Public Baths Wastewater Pump
Stations Modification at
Kapiolani Park (Queen's
Surf Beach)

Subject: Notice of Determination - Finding of No Significant Impact (FONSI)
for Public Baths Wastewater Pump Station Modification
Honolulu, Oahu, Hawaii
TMK: 3-1-31:7

Final Environmental Assessment
**PUBLIC BATHS WASTEWATER
PUMP STATION MODIFICATION**

**FIGURE 3.2
EXISTING LAND USE
AND ZONING MAP**

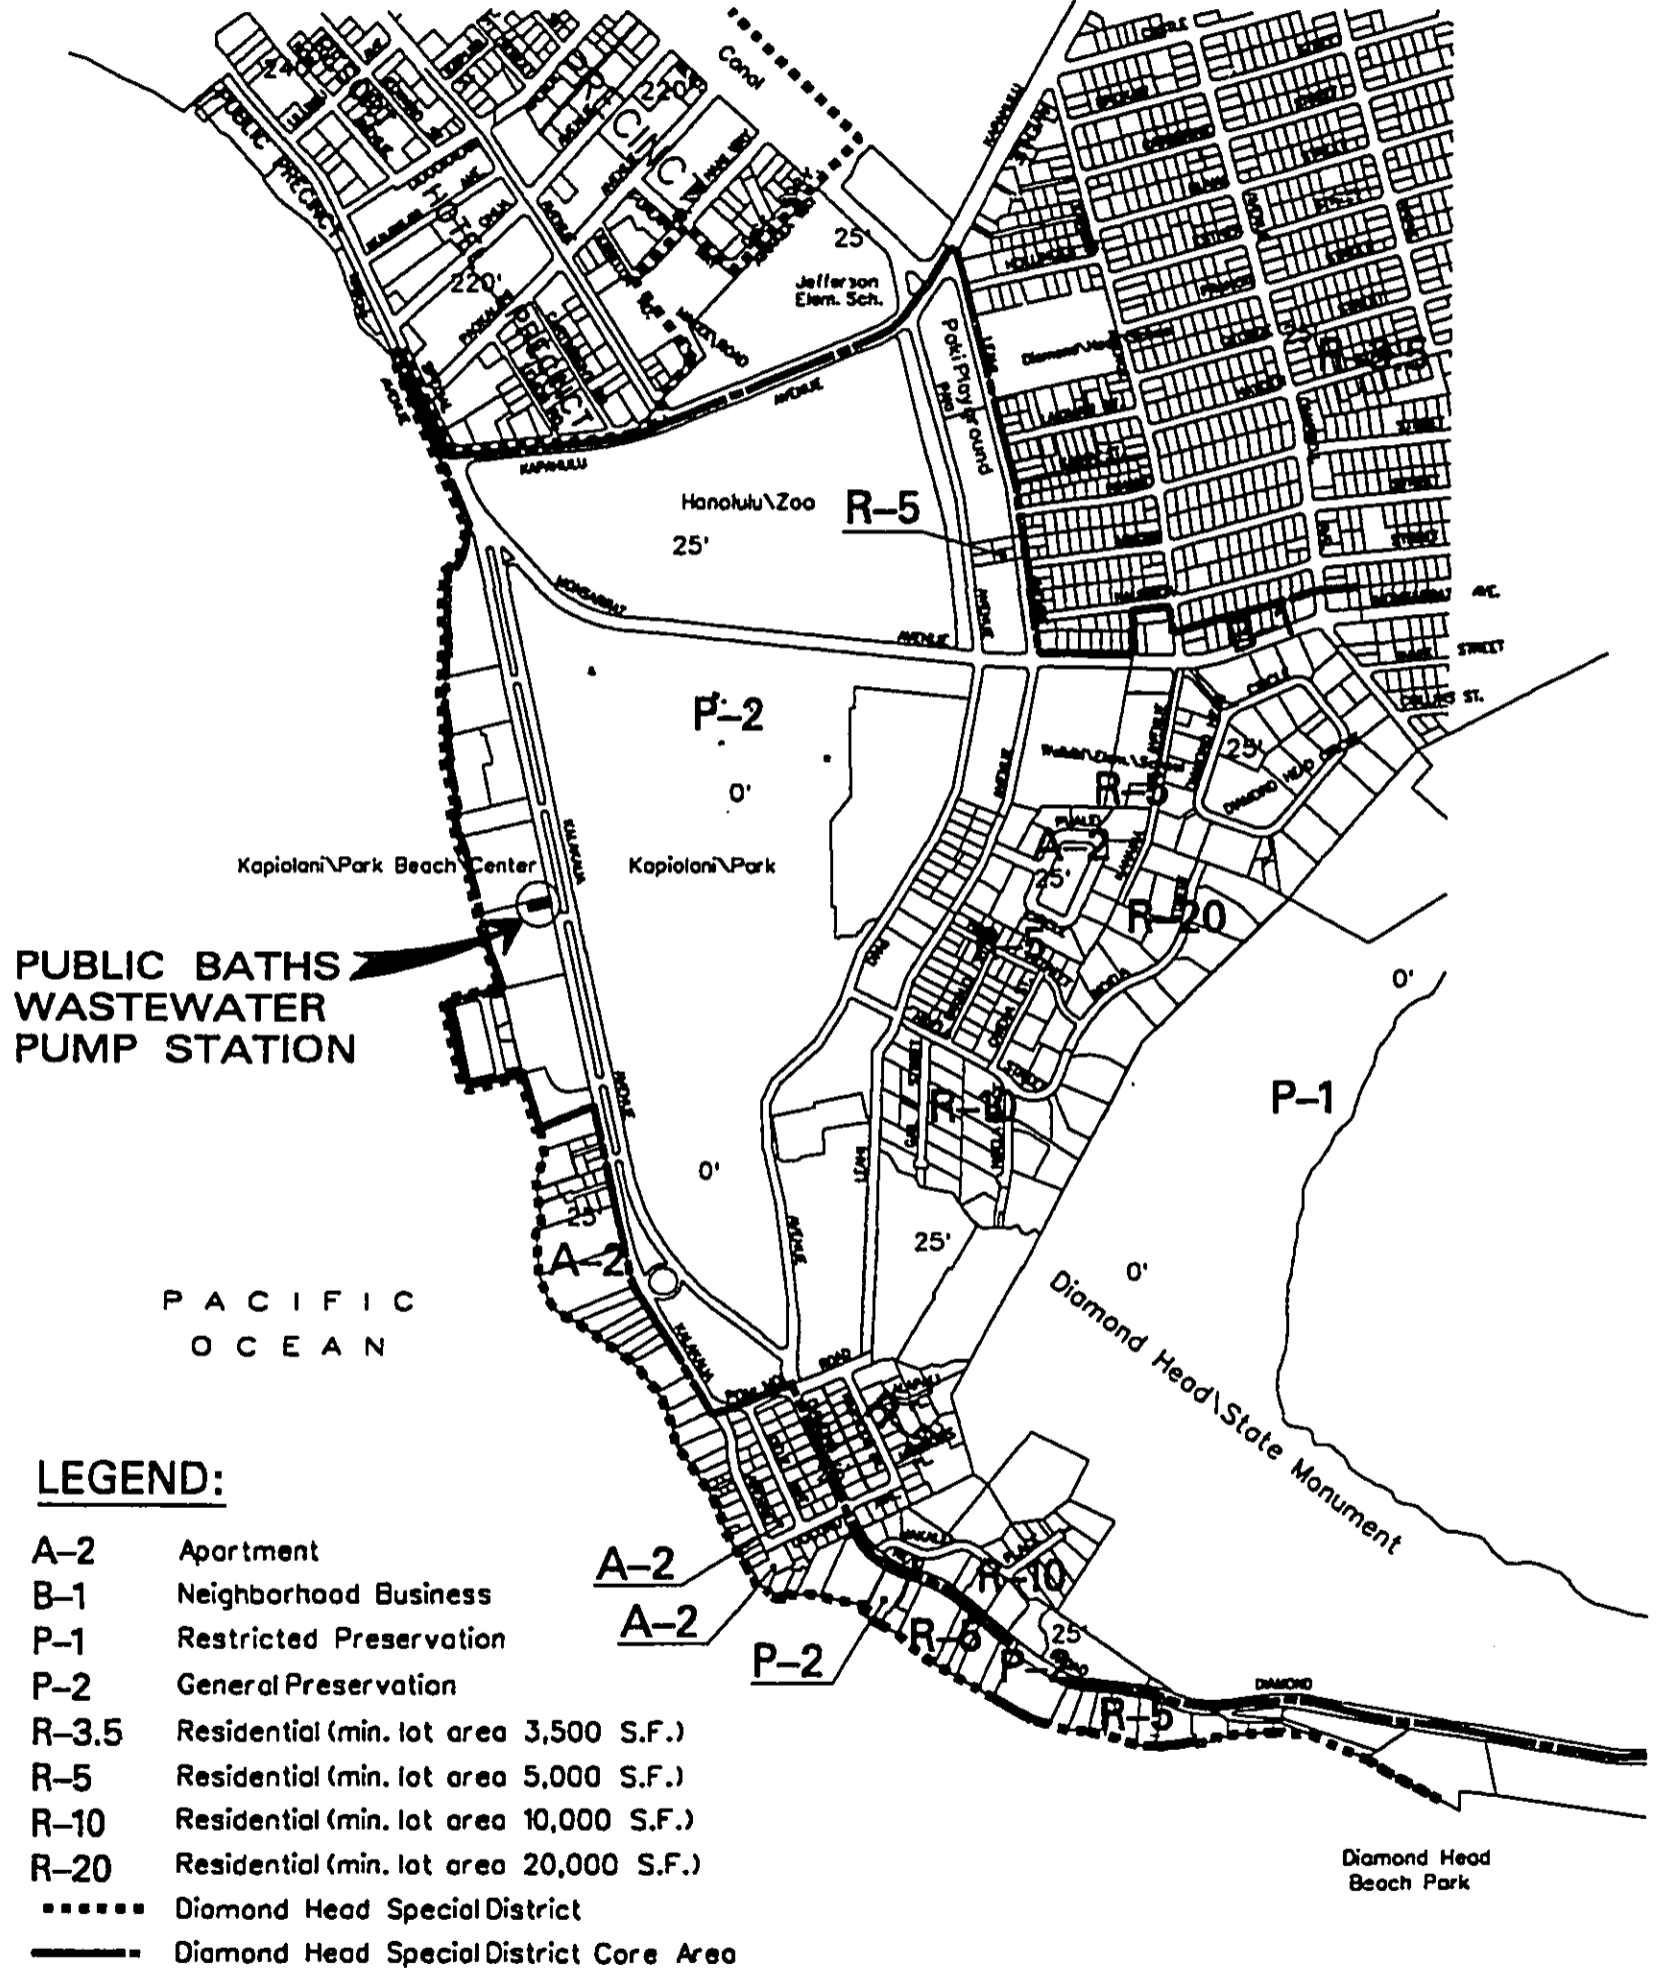
- A. The DEA shows on Figure 3.2 (3-6) that a zero-foot (0') height limit is stipulated for the park land where the pump station expansion is proposed to be situated. Is all structural and equipment expansion proposed for the park land adjacent to the existing pump station planned to be installed underground so as not to interfere with the view plane to the shoreline?

7.a. *The DEA shows on Figure 3.2 (3-6) that a zero-foot (0) height limit is stipulated for the park land where the pump station expansion is proposed to be situated. Is all structural and equipment expansion proposed for the park land adjacent to the existing pump station planned to be installed underground so as not to interfere with the view plane to the shoreline?*

FIGURE 3.7

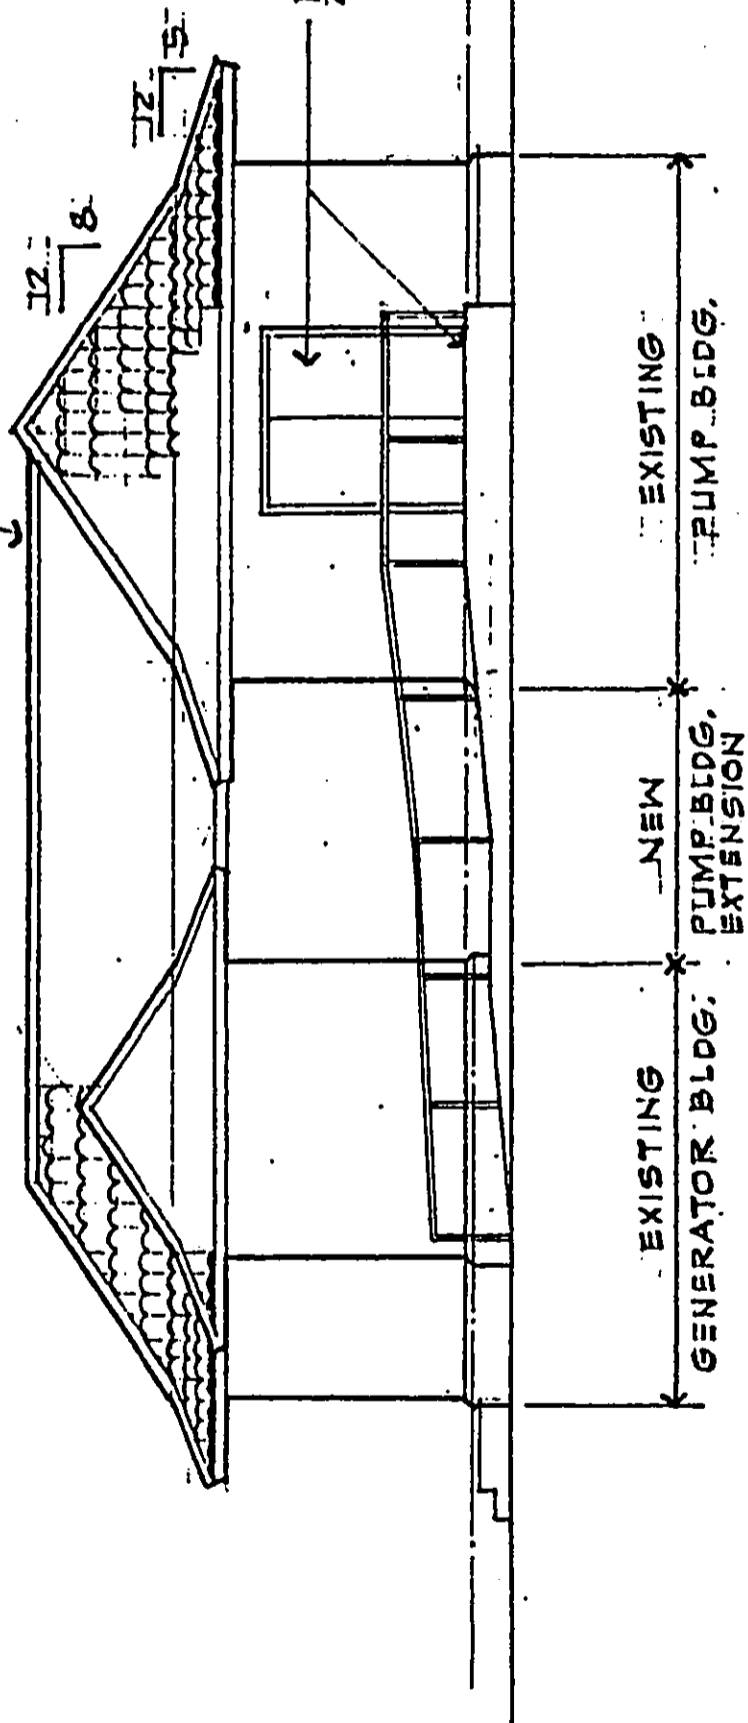
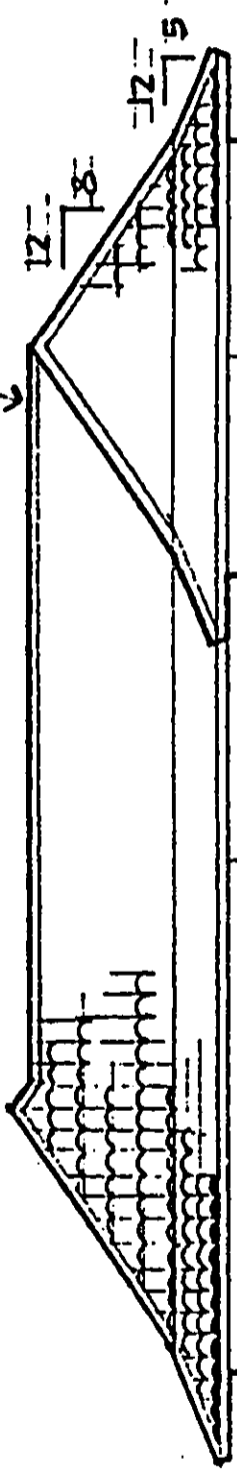
Figures 3-6, 3-7, and 3-8 show that the original stand-alone pump station building's architectural integrity is obliterated with attached structures and a common roof of contemporary material whose quality is inferior to the original. The contemporary roof tile on the generator building does not conform with the original roof tile of historic architectural value on the pump station building. Further, the fibrous cement roof tile material proposed as "similar to the existing" is known to a) harbor common algae that causes discoloration and to b) fade in color over the short term.
